Proposed Revisions to a Standard Plans Index

Index Number: 521-426

Sheet Number (s): 2 of 4

Index Title: TRAFFIC RAILING - (MEDIAN 36" SINGLE-SLOPE)

SHEET
2 of 4

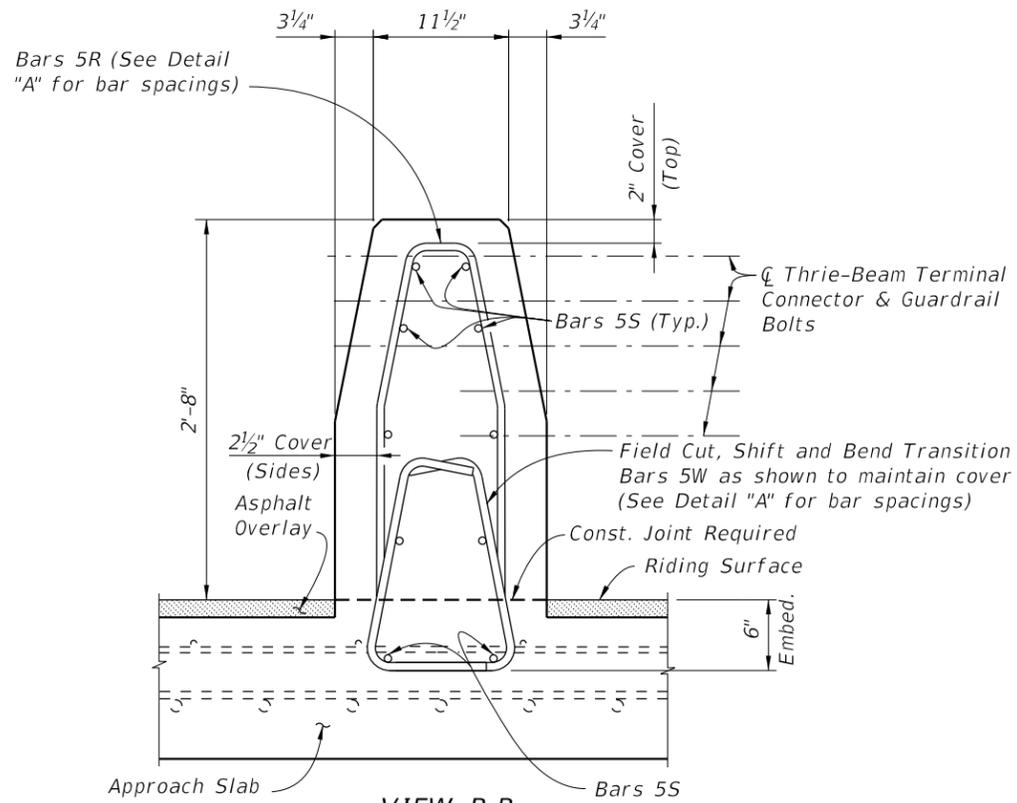
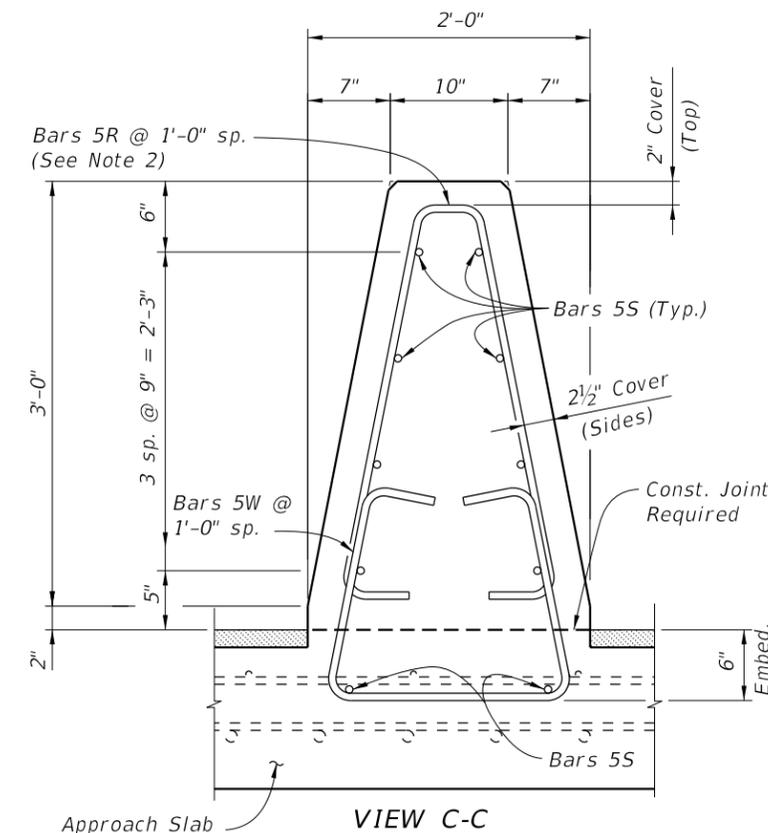
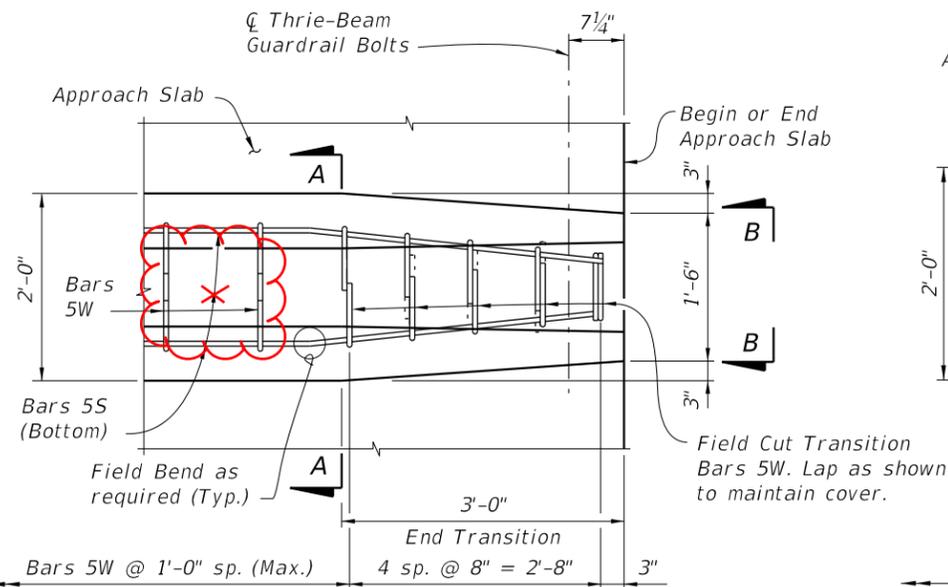
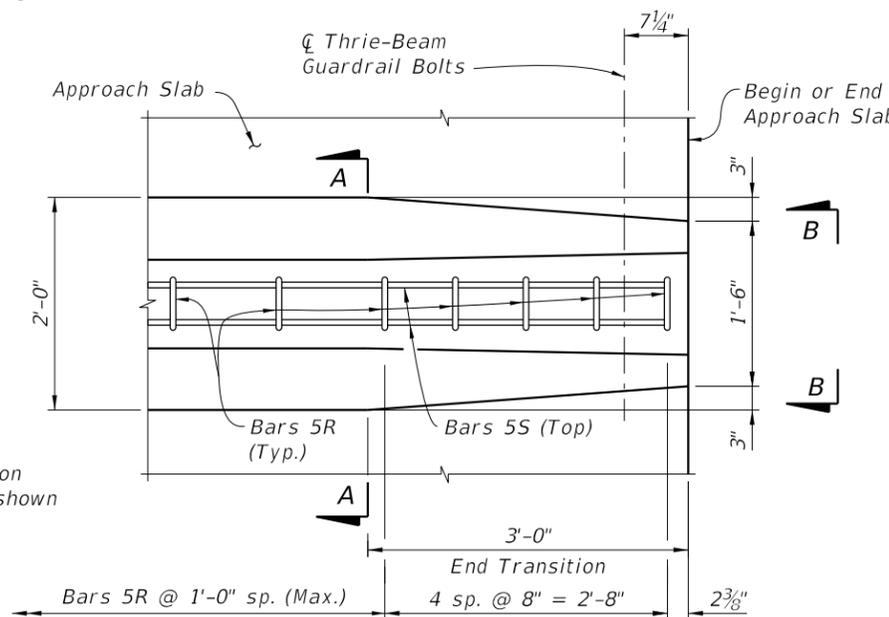
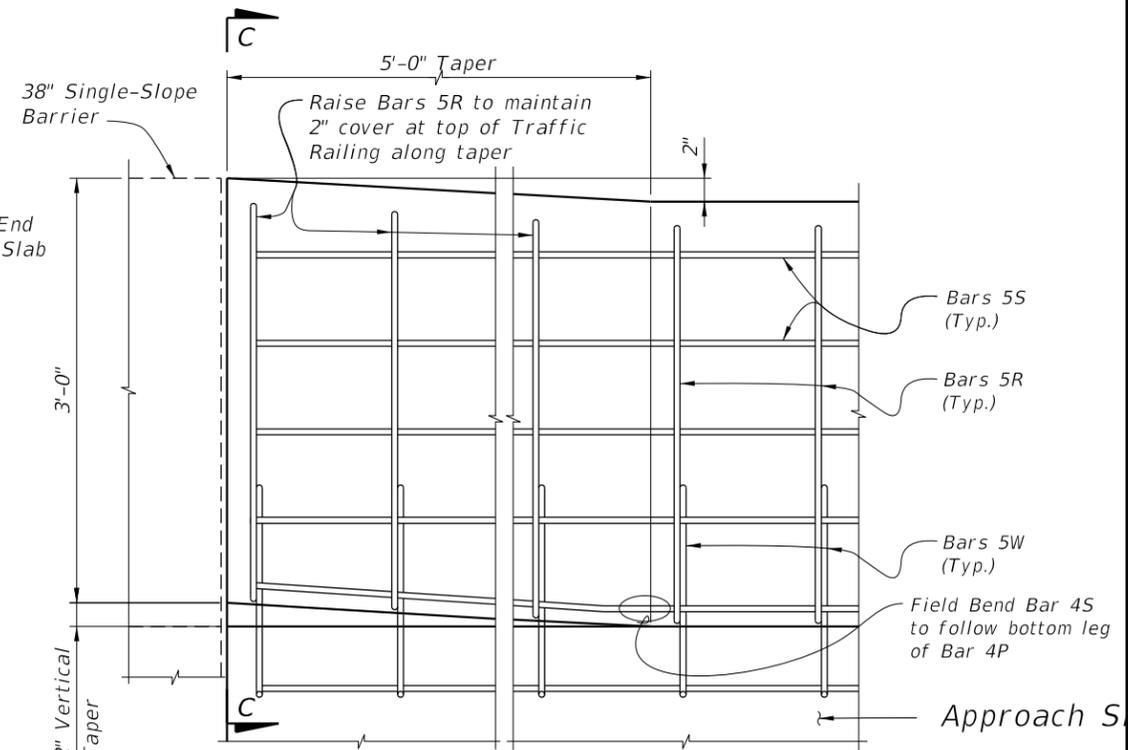
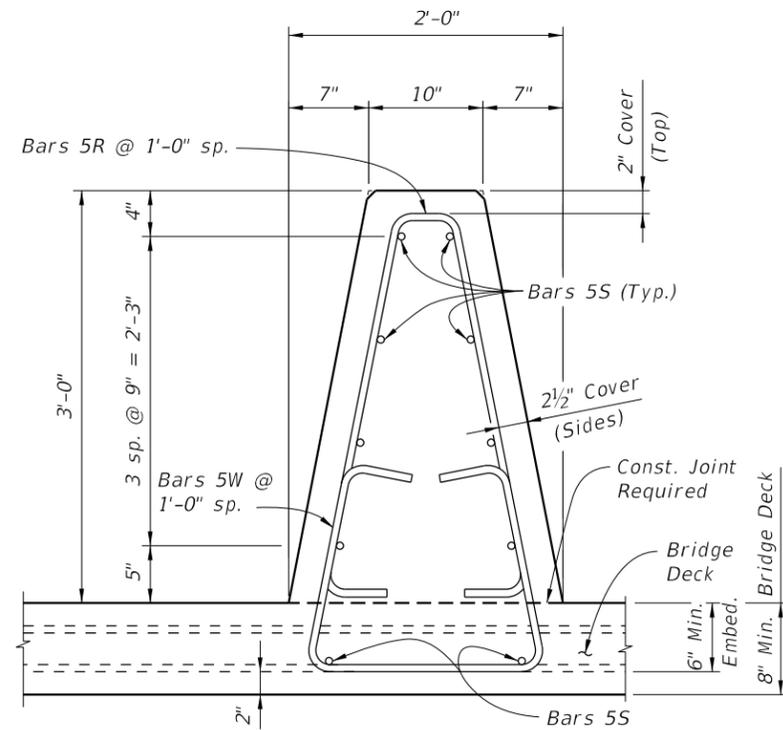
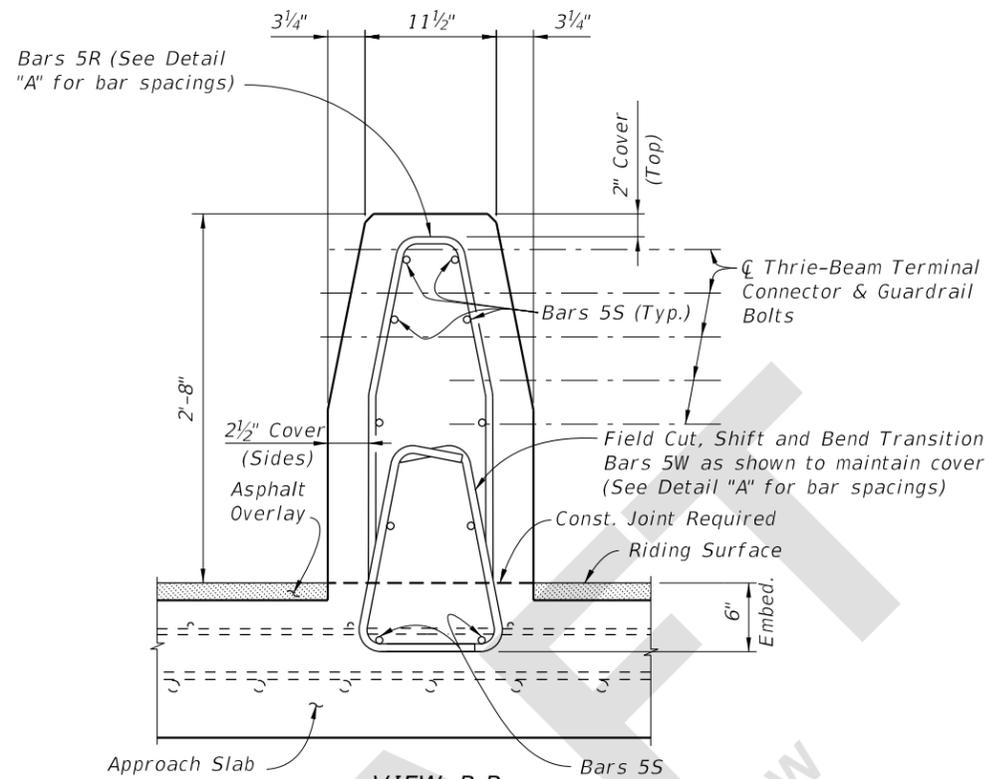
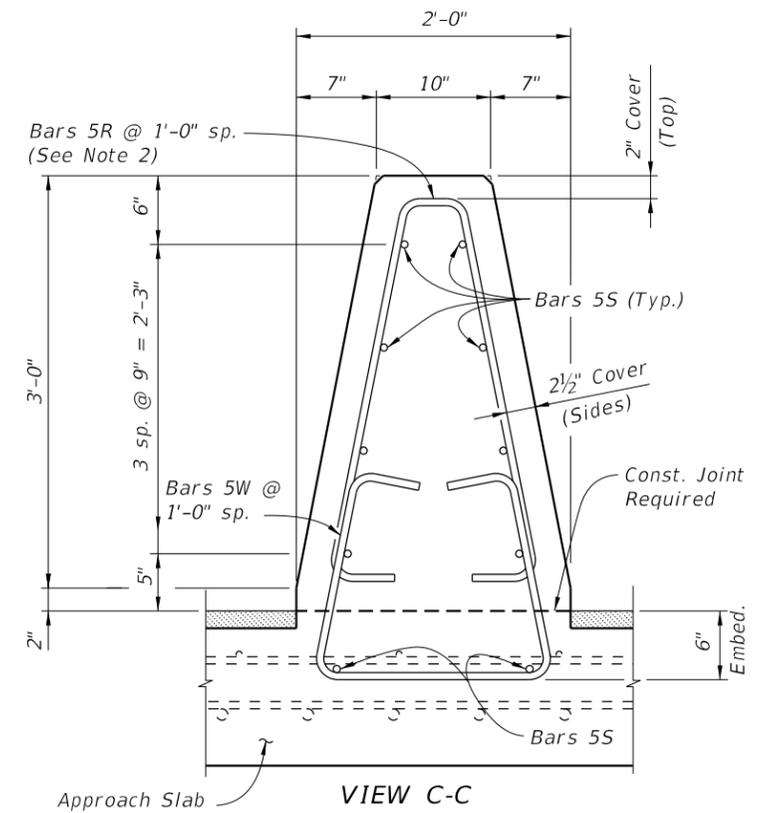
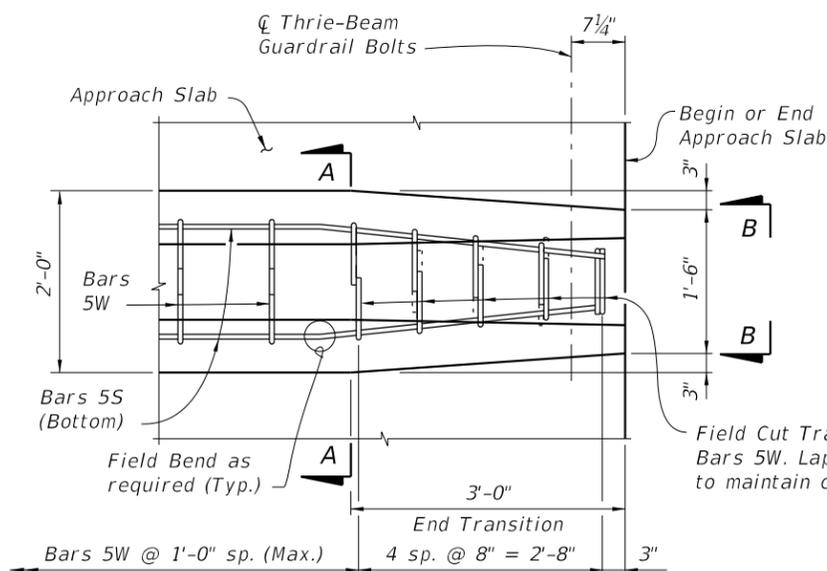
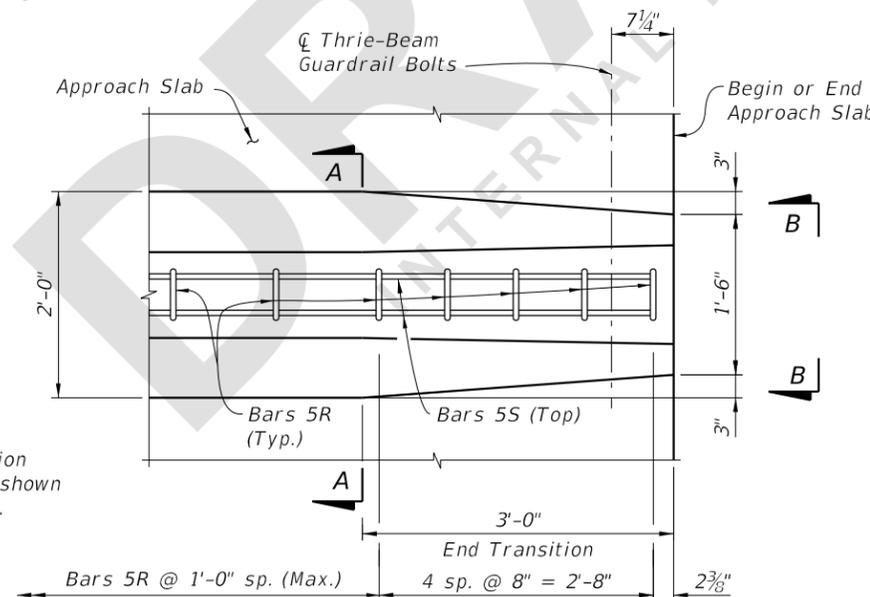
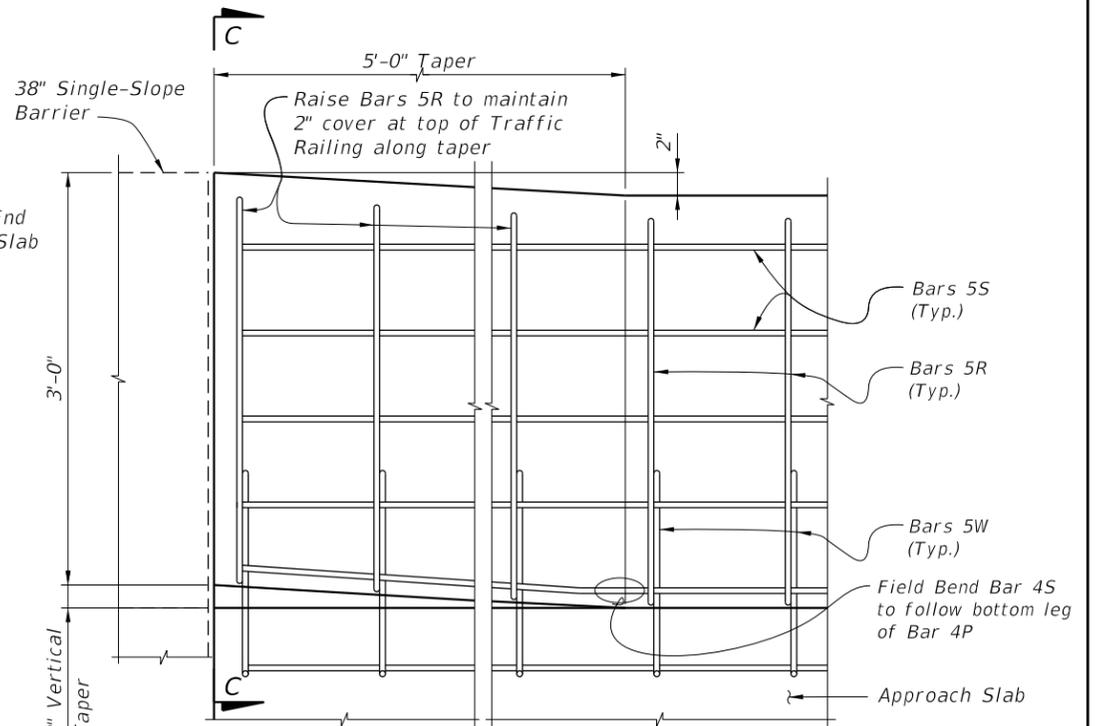
Sheet 2: Removed an arrow that did not point to anything.

There was an arrow that didn't point to anything. Presumably it was supposed to point to a bar that may be added per the SPI, however, the bar is not shown in the plan and the arrow only causes confusion. Therefore, it was removed.
